CEC Draft Computer Standards (Docket #12-AAER-2)

Intel and Dell Comments on Aggios' Report¹

In Appendix C Notebook Demonstration Project
Phase 3 - Notebook Power Management Analysis and Demonstration
Part I - Opening up the Power Management (Version 1.0; submitted 10/27/2014)

Dated: May 29, 2015

Figure 1 - Comparison of APM (left) and ACPI (right)

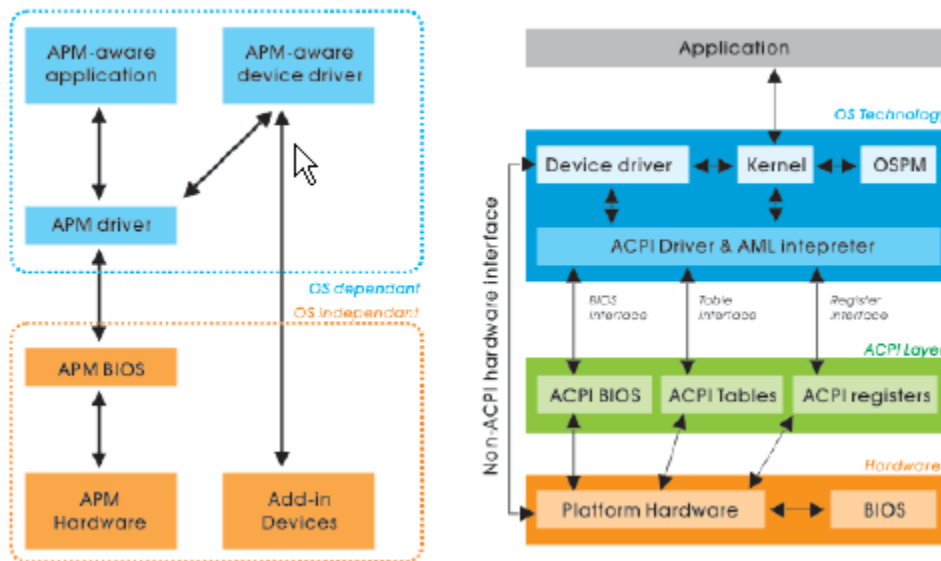
APM: This is essentially the first generation of power management. APM provided basic power management mechanisms through an interface to BIOS, but it had significant downsides, such as (a) its reliance on BIOS to enter low power CPU states (vs. ACPI where idle state is directly entered by OS) and the BIOS firmware execution (uncached) overhead of such requests, (b) control of only the most basic interfaces (sleep states, hard drive, display, etc.), and (c) the BIOS interface was not compatible with Microsoft Windows® long term OS direction (NT-based vs. Windows® 9x) where the OS was multi-threaded and capable of multi-processing.

ACPI: APM had one big problem alluded to earlier, i.e. BIOS had no sense of what a machine is doing with respect to usage model. For example, if a user is downloading a huge file, it might be okay to put the monitor to sleep, but it's obviously not okay to put the network and/or HDD asleep which would sometimes happen due to odd "hiccups" in the download stream (heavy server load, lag, etc.). Thus, power management (PM) had to be moved away from the "usage model ignorant" BIOS to the more usage-model savvy and aware OS. ACPI is essentially PM done by the OS. It encapsulates standards that the OS, apps, drivers, and hardware must follow in order to do PM intelligently and elegantly throughout the system.

ACPI introduced concepts that allowed for OS-control of power management that included a new interpreted language for doing configuration and power management (ASL/AML), invocation of BIOS-supplied control methods to perform platform specific actions in a manner that was OS-friendly (e.g. multi-core, multi-thread) as well as formal definitions and semantics for CPU, system and device level low power states (C, S, D).

The framework is very robust, and it continues to advance to this day. For example, the CPU idle infrastructure has been used to innovate around CPU idle states with only minor changes since 1995 (when only C1-C3 existed), through the addition of SMT and multi-core products, to the addition of C states (CC1-CC6, PC1-PC10).

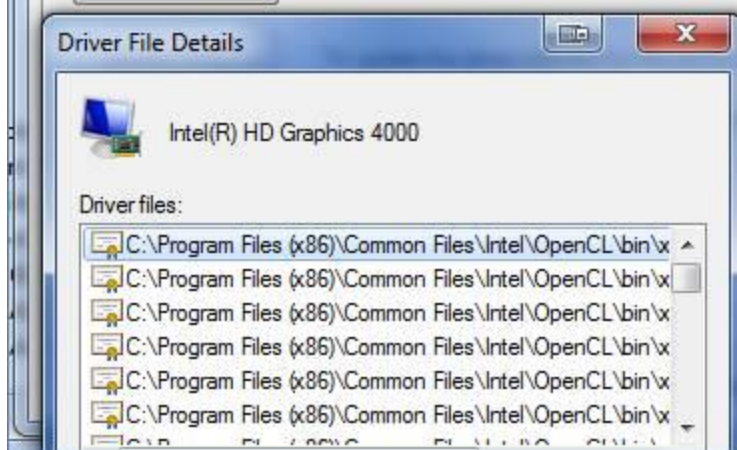
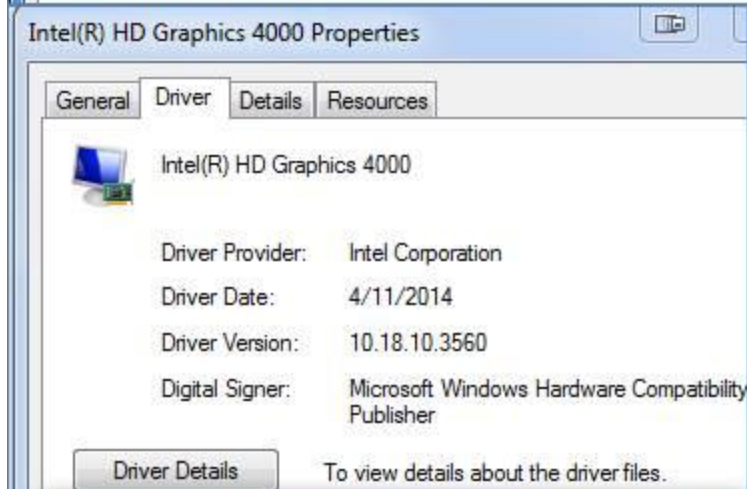
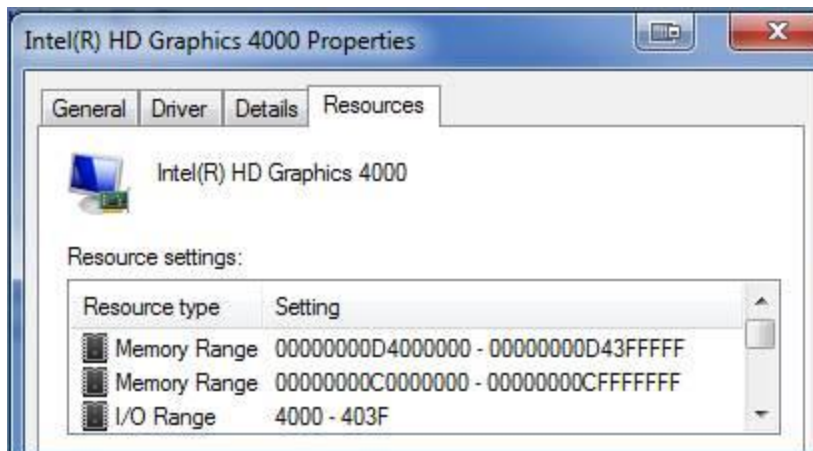
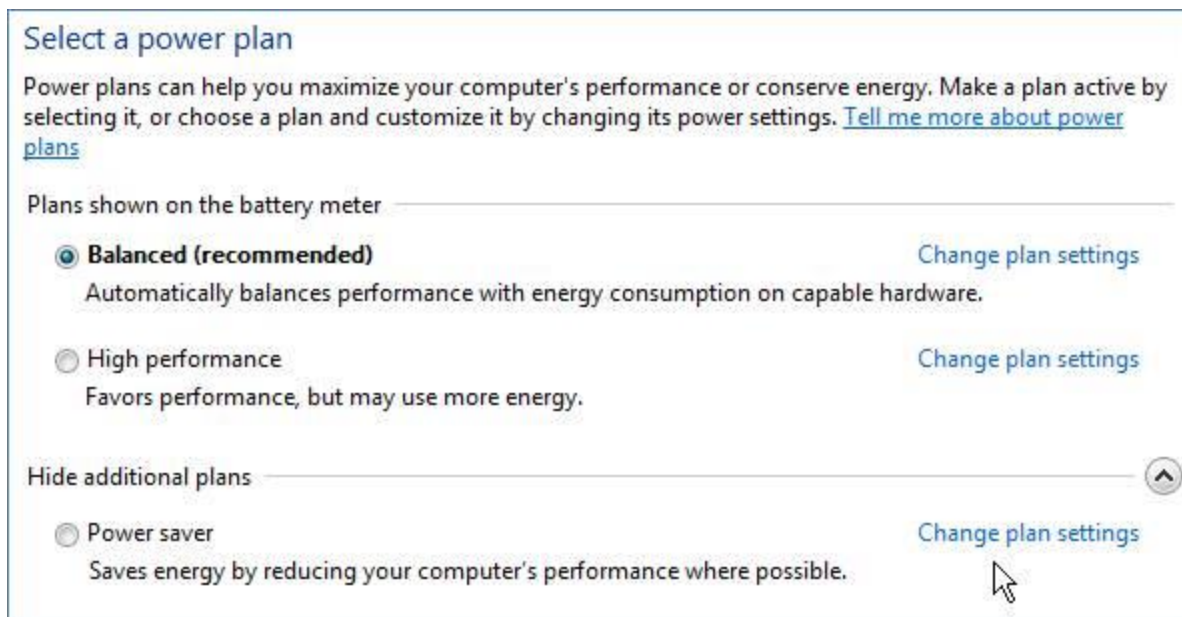
Note: Capping maximum performance and power can also have drastic impact on energy consumption of a task. While limiting the maximum power can reduce measured wall power it may increase the time and resulting energy consumed to complete any given task. Even moderate demand workloads can benefit from allowing the platform and SOC to burst to a much higher performance for short periods of time. Abstracted controls in software or even end-user settings may actually increase the total energy consumed by the platform due to misunderstood and poorly set values and controls. Dedicated hardware and pre-configured controls that are set and not configurable, in many cases, create a more guaranteed user experience and power usage profile. Configurable settings, may in fact, allow the consumer to inadvertently increase the overall energy usage, as many of the energy controls could damage user experience, especially when the user perceives that just turning everything to maximum always guarantees the best experience. Educating the software developers and end-user consumer is a daunting task that could substantially increase the cost of PC platforms. Additional support for hardware, software and device vendors and handling end-user service calls and issues can be a large cost adder to the industry, and is not comprehended in this analysis.

Intel and Microsoft actively discuss better means to applications and services to improve energy consumption. While it is true that some APIs could and are being established for applications to expose its usage and resource demands, the value and viability of such an approach is questionable. It is relatively simple for a bad application to take advantage of the API infrastructure to abuse its power and resource allocation and starve the other well behaved applications. Enforcement and correction of bad applications is extremely costly. Other concerns around complexity due to security, hacking, and relative value to other efforts, remain as inhibitors to large scale development and adoption. Meanwhile the PC industry continues to reduce platform power at an amazing rate relative to other consumer devices.
